CITY COUNCIL PROCEEDINGS
January 14, 2026

CHANGE ORDER NO.: 8

Owner: City of David City Owner's Project No.:
Engineer: JEO Consulting Group, Inc. Engineer's Project No.: 251034.00
Contractor: BRB Contractors, Inc. Contractor's Project No.:
Project: Wastewater Treatment Facility Improvements
Contract Name:
Date Issued: 1/9/2026 Effective Date of Change Order: 1/14/2026

Attachment(s) Figure - Proposed Site Plan & FM Modifications

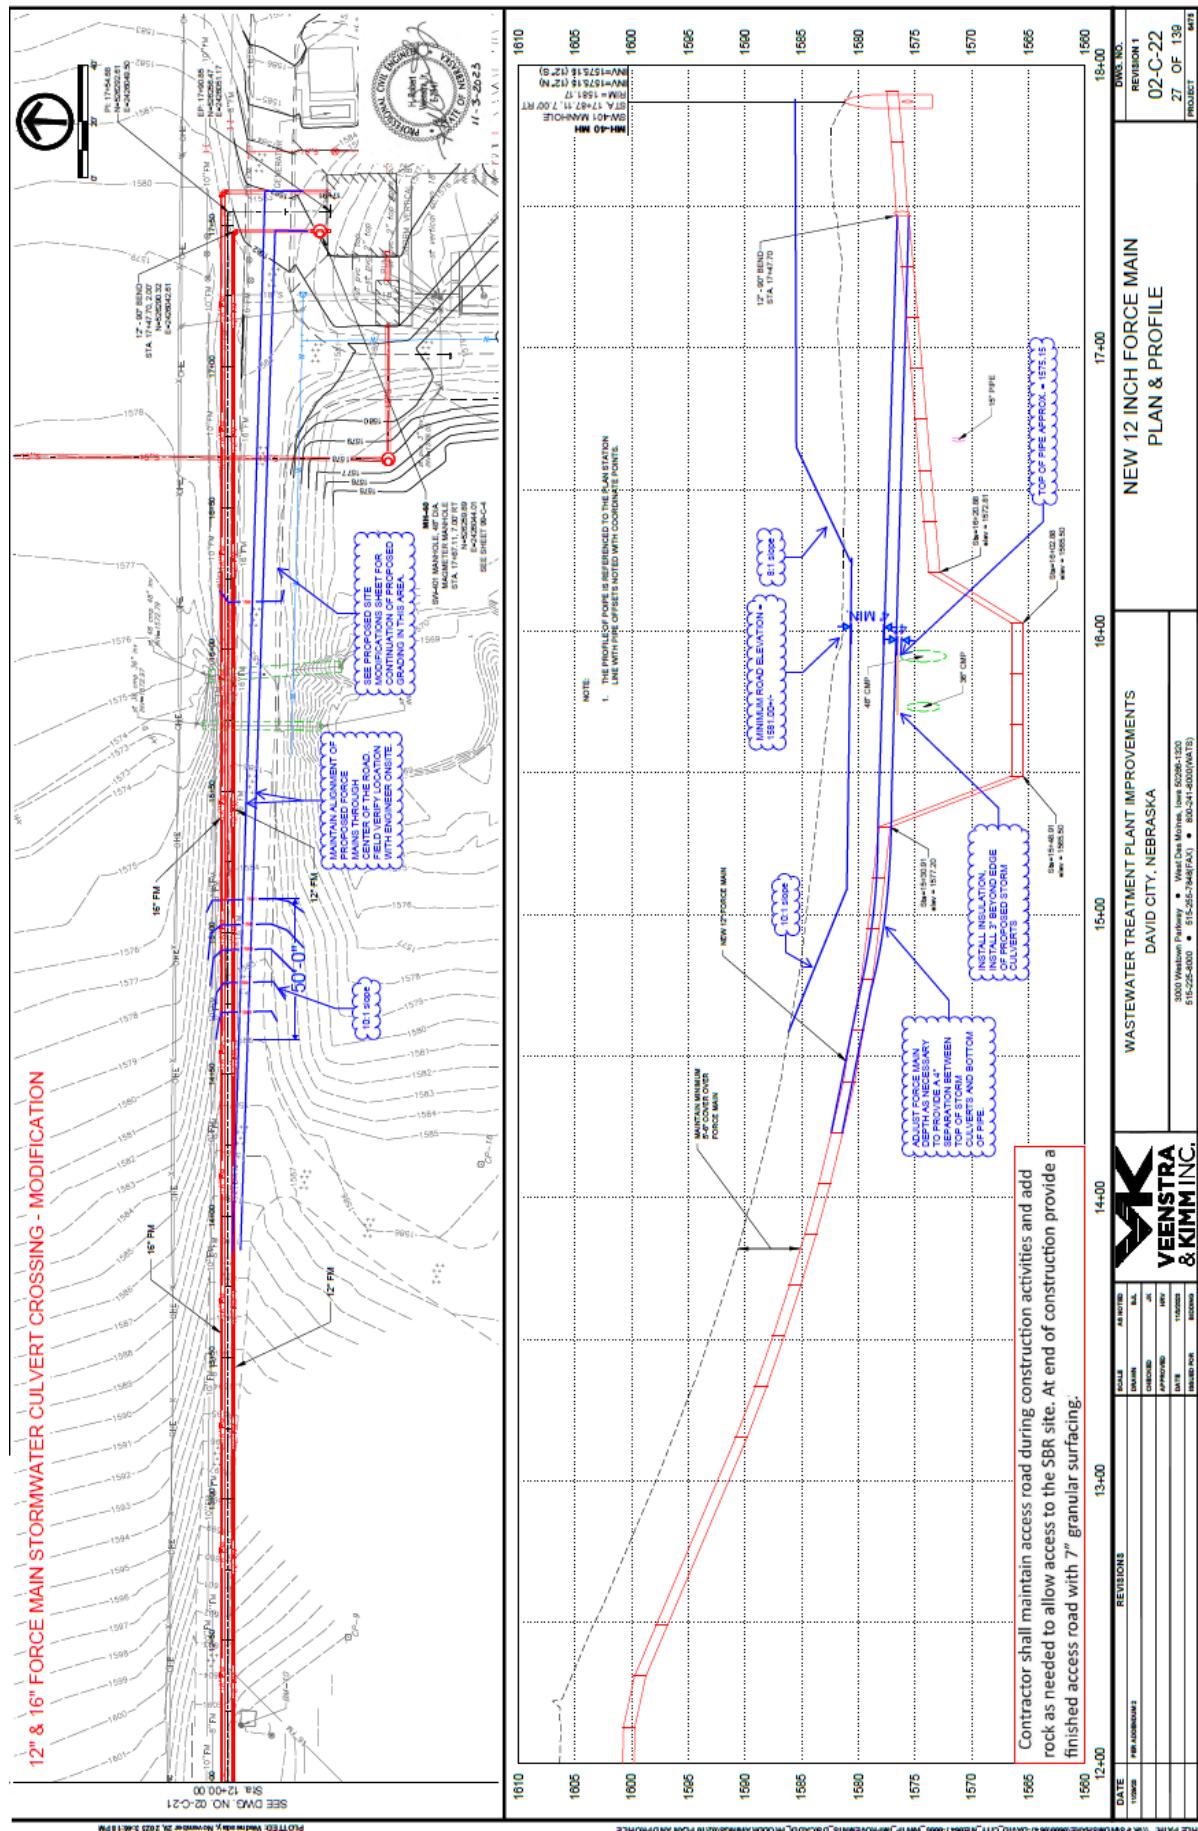
Description The following is a change to the scope of work to modify the proposed grading plan at the East Site. This work includes additional earthwork, deduct of STR-3, STR-4, P-4, and an area intake, raise rim elevation of AGP Flume's influent manhole, raise rim elevation of MH-1, modify storm sewer south of driveway, additional granular surfacing, and modify the 12" and 16" force main to be installed above the two existing storm culverts across the access road.

Purpose of Change Directive This change is to provide sufficient flood protection for a 500 year rain event to the East Site of the Wastewater Treatment Facility. This site is considered a critical facility, therefore, the Nebraska Department of Natural Resources requires flood protection to be a minimum one foot above a 500 year rain event. As stated in the Wastewater Treatment Facility Improvements Peer Review, JEO performed a site specific evaluation to determine the Base Flood Elevation (BFE) for a 500 year event. It was determined the BFE north of the access road to be 1584.48. As a result, the proposed berm has an elevation along the north road at 1585.50. The access road west of the site was also modified to allow it to be overtopped since the existing culverts are undersized. Additional information about this recommendation and evaluation can be found in the Peer Review.

Attachment(s) Sheet 99-A-2 - Modifications to Detail 299

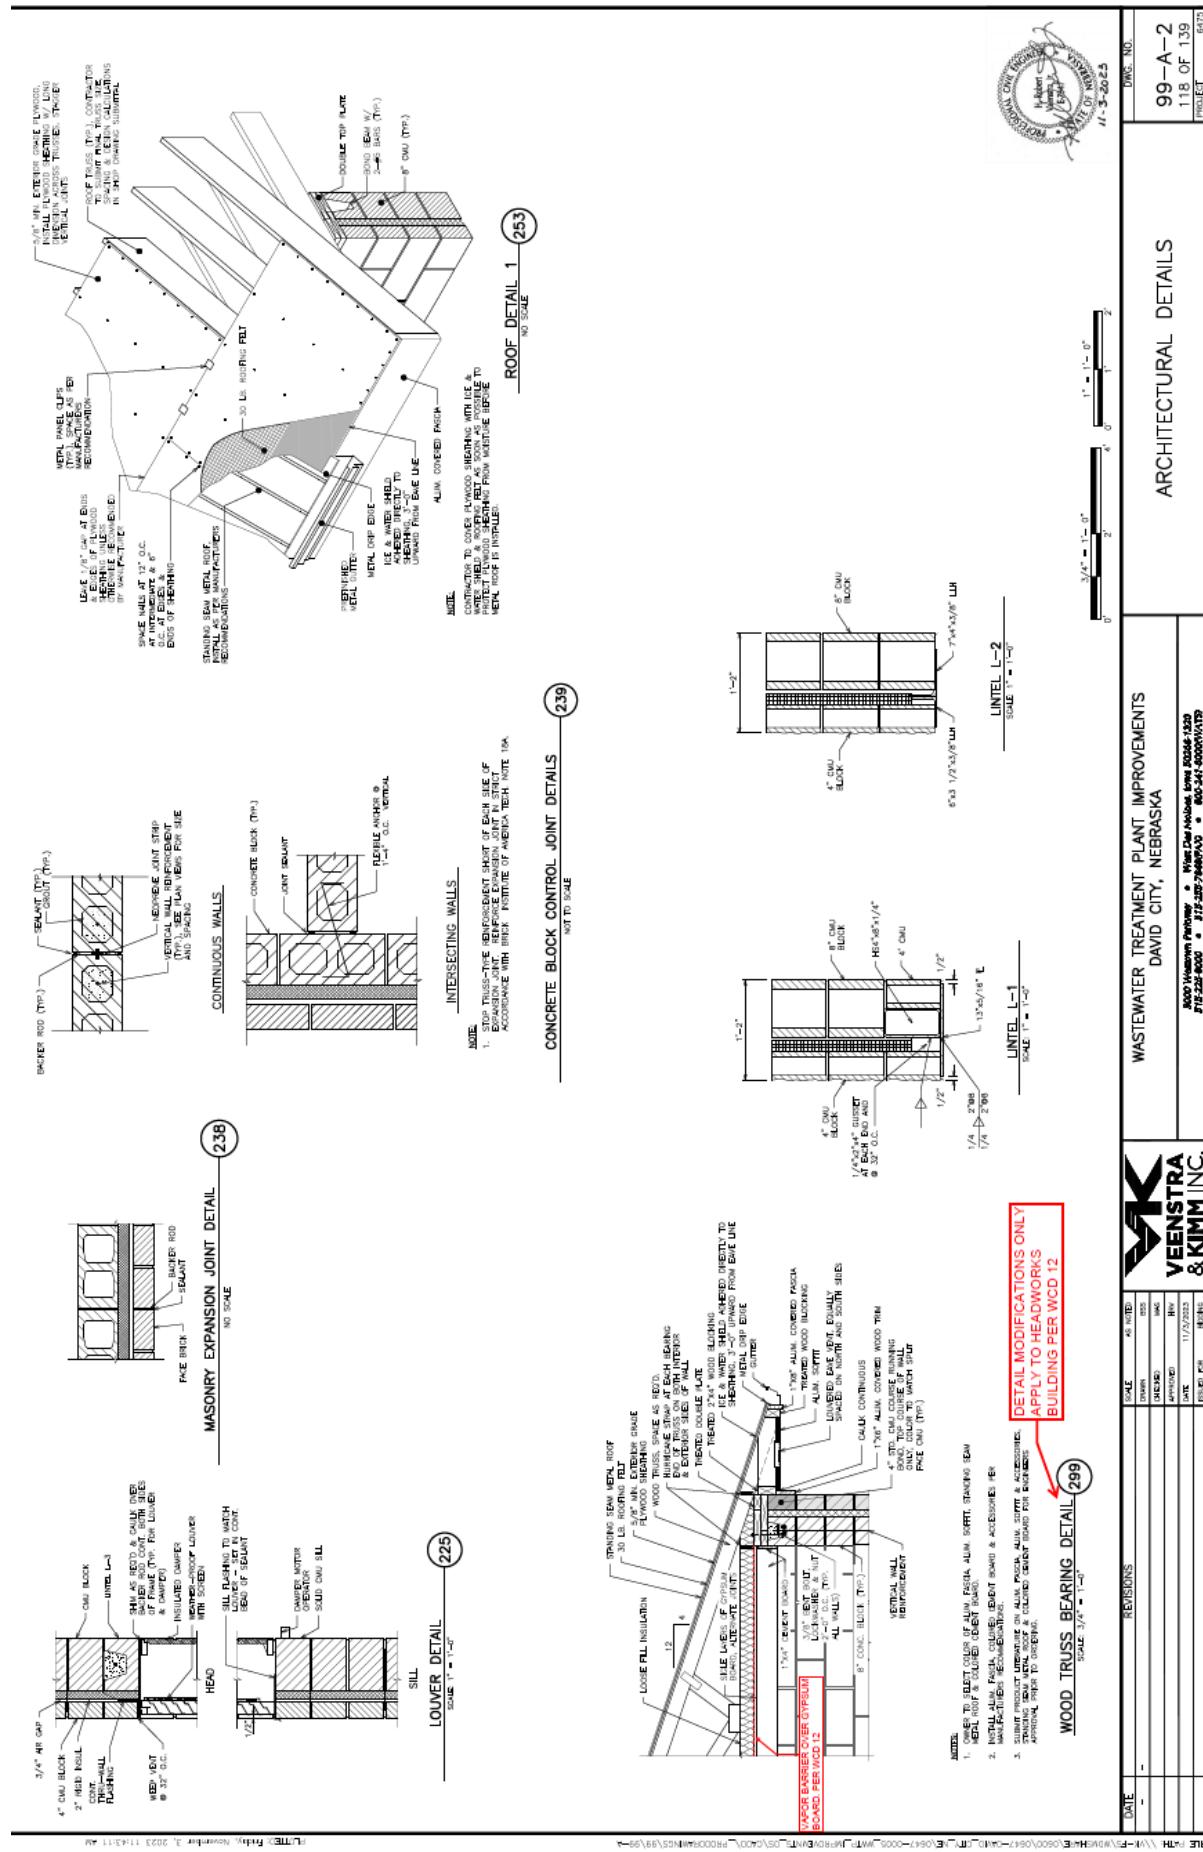
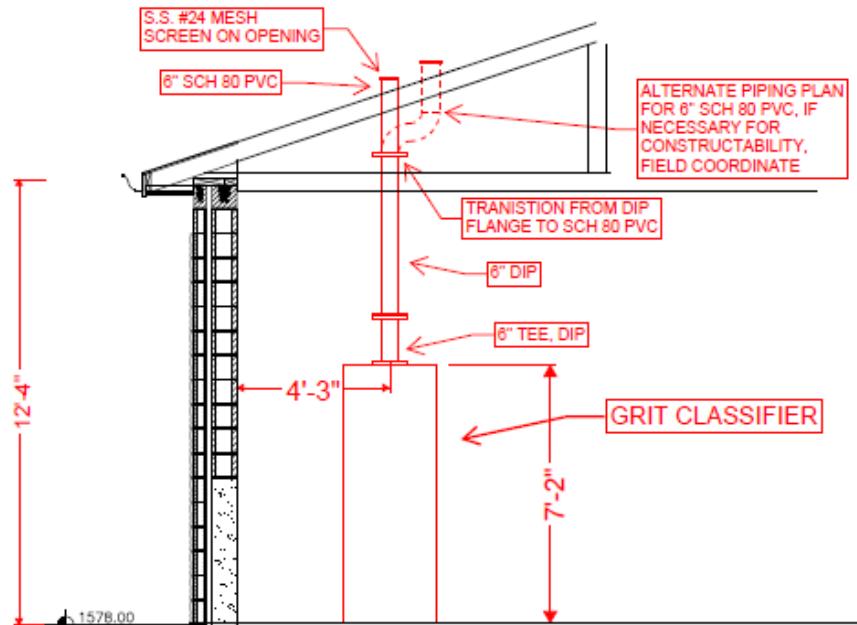
Description Change to the scope of work to add a vapor barrier to the ceiling of the headworks building and additional piping for grit classifier ventilation.

Purpose of Change Directive To provide adequate venting for the grit classifier and seal off the attic of the headworks building to provide a classification separation between the room and the attic.

Sheet 02-C-12 - Modification to Grading Around SBRs

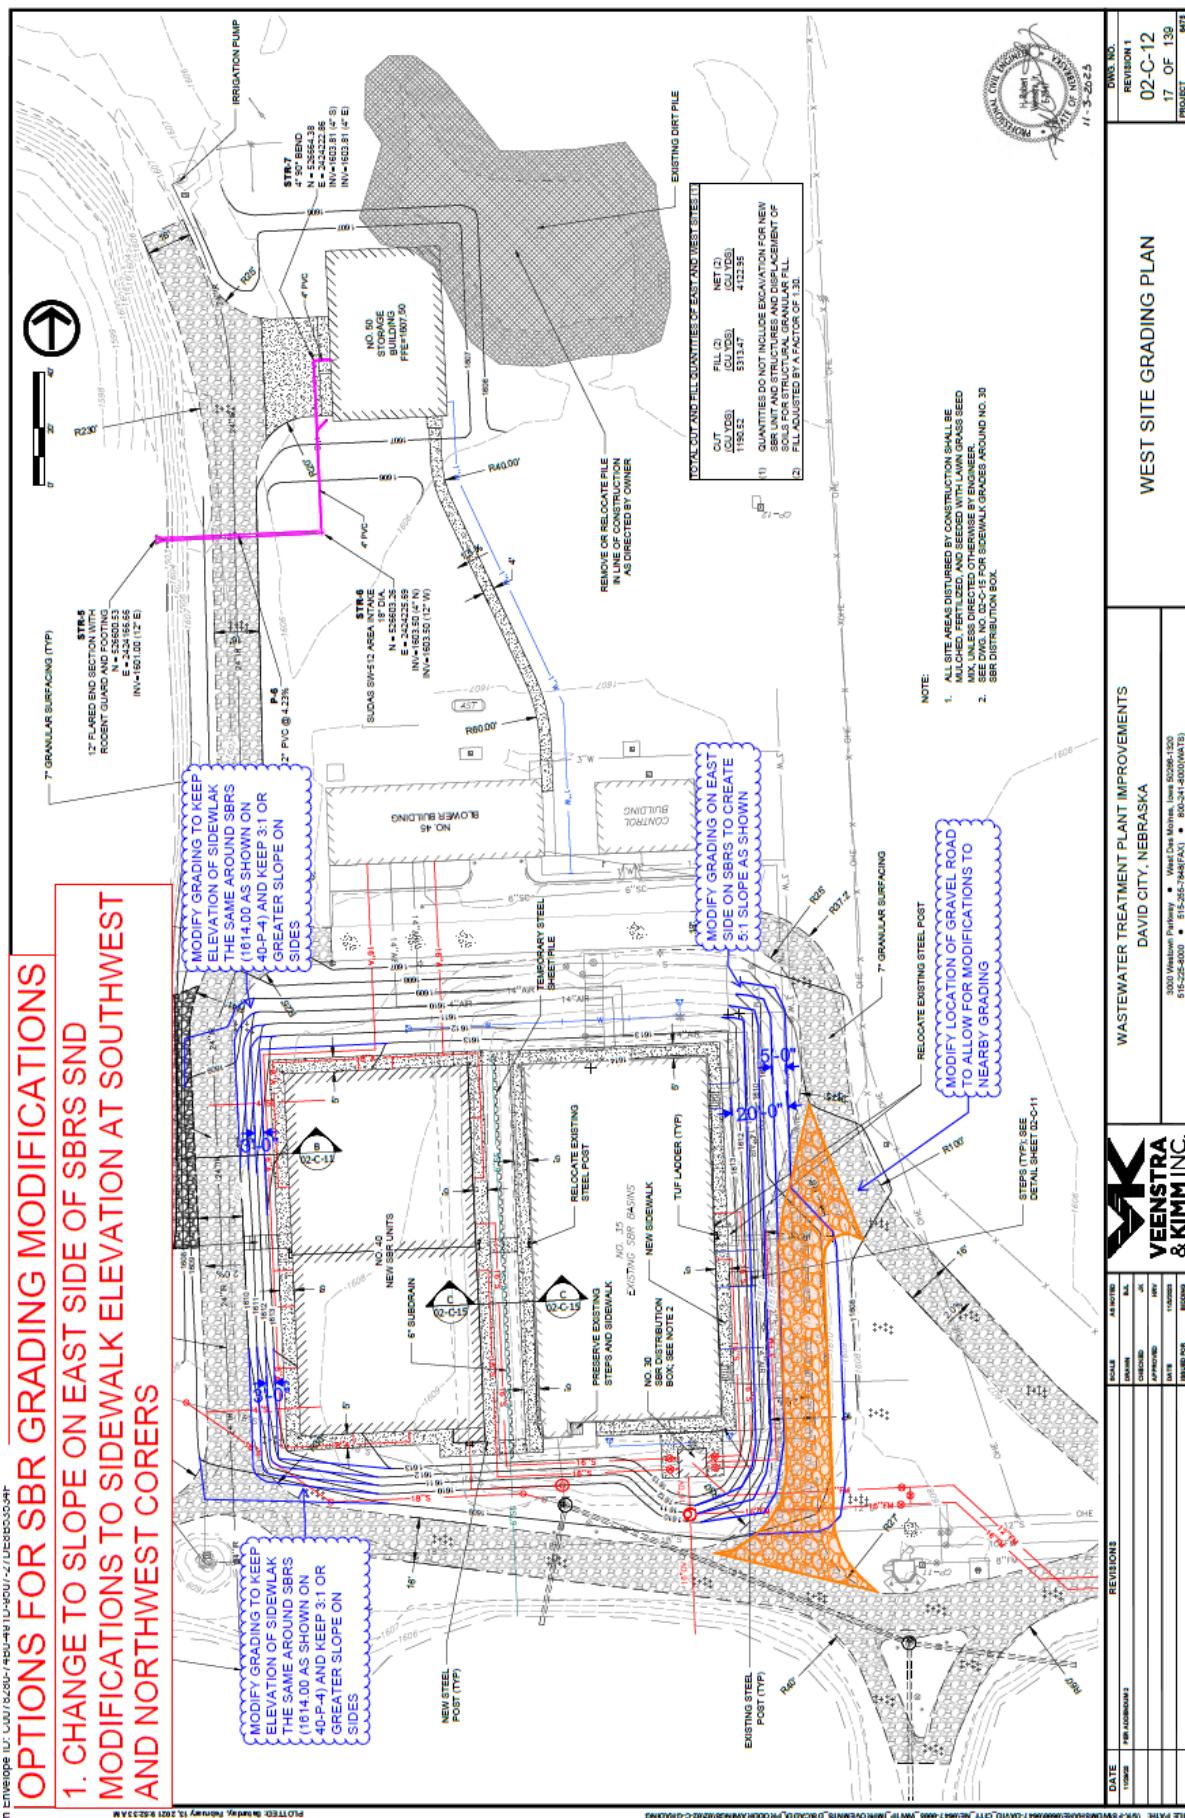
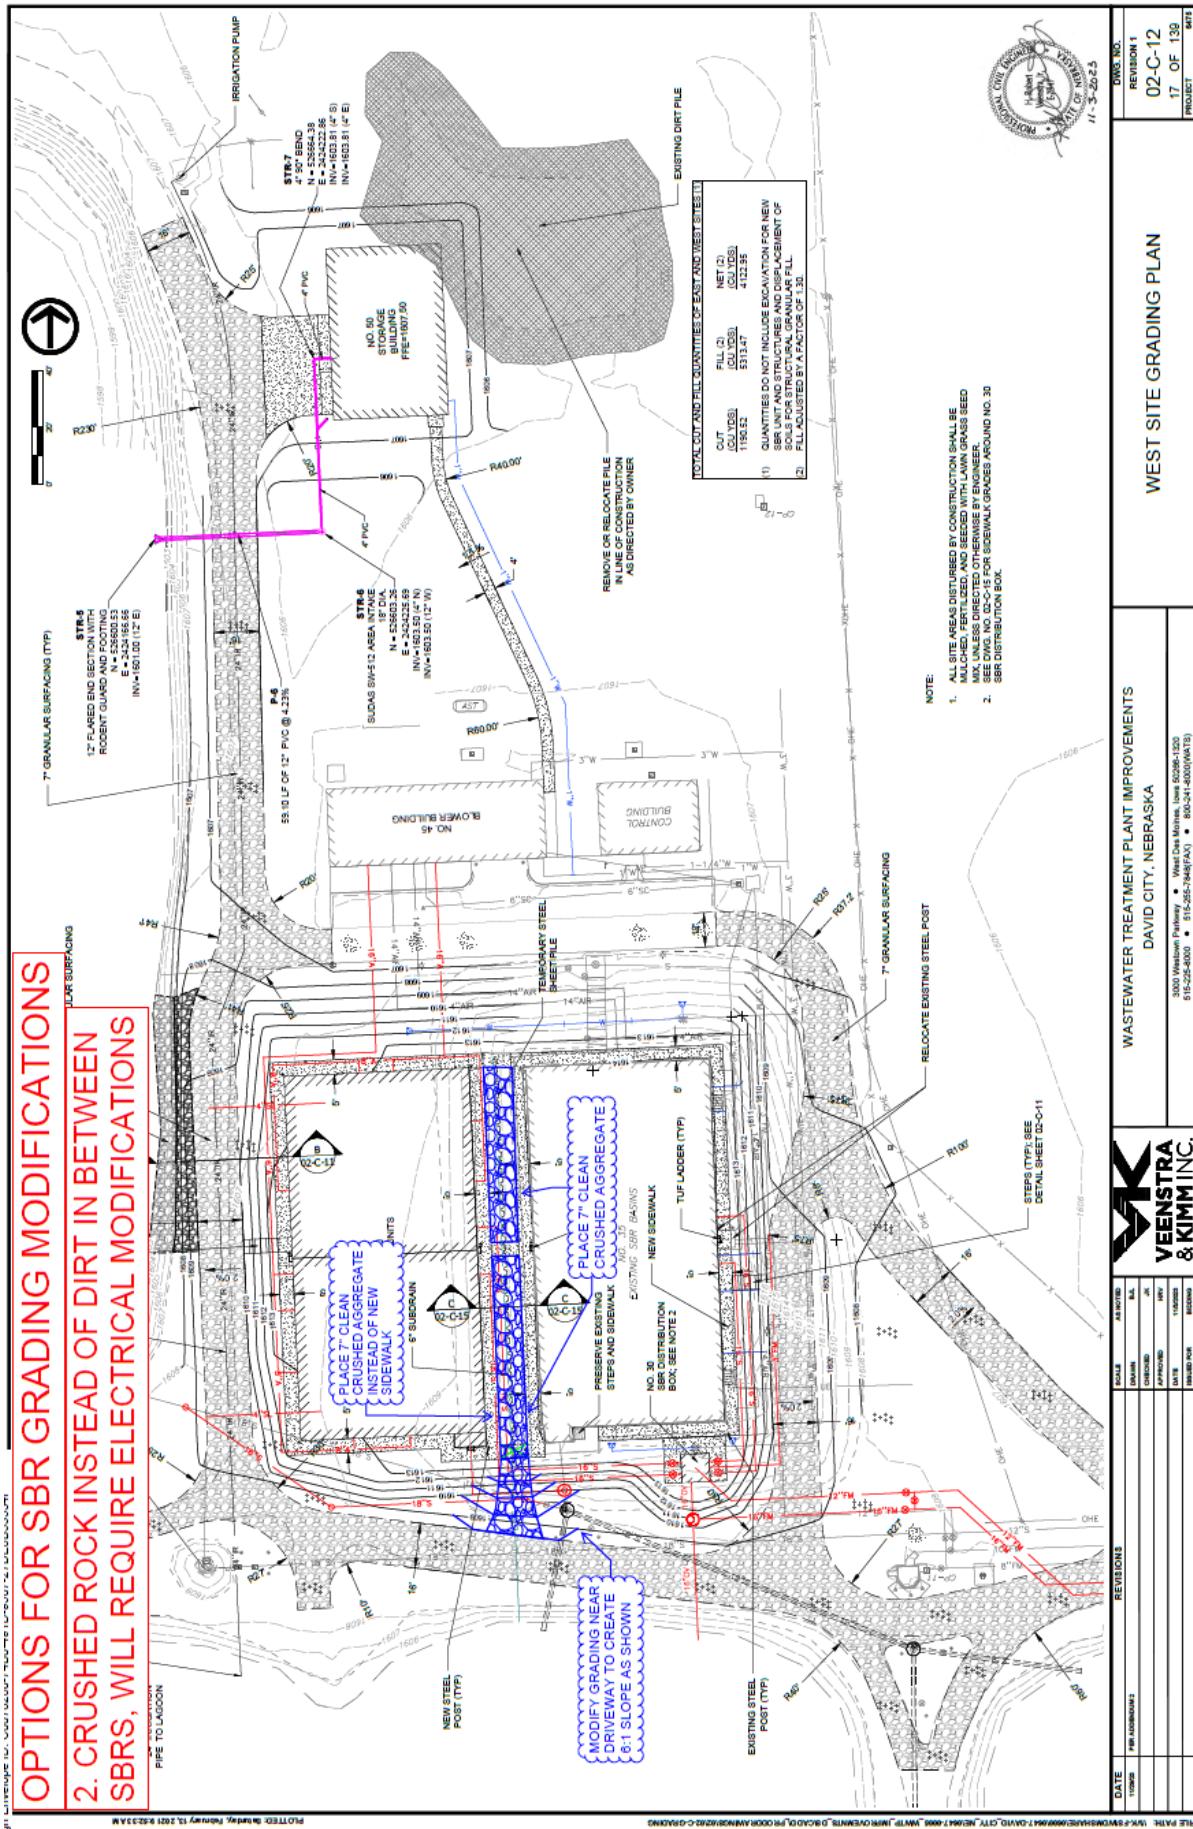
5. WCD #16 - SBR Grading Modifications: \$52,196.89. Adjust grading around the SBR, so the sidewalks are all at the same elevation and staff can reach equipment to service it instead of using a ladder. Includes some rock to allow for vehicle service access between the SBR basins and moves some electrical items outside the hazardous location envelope around the SBR basins.
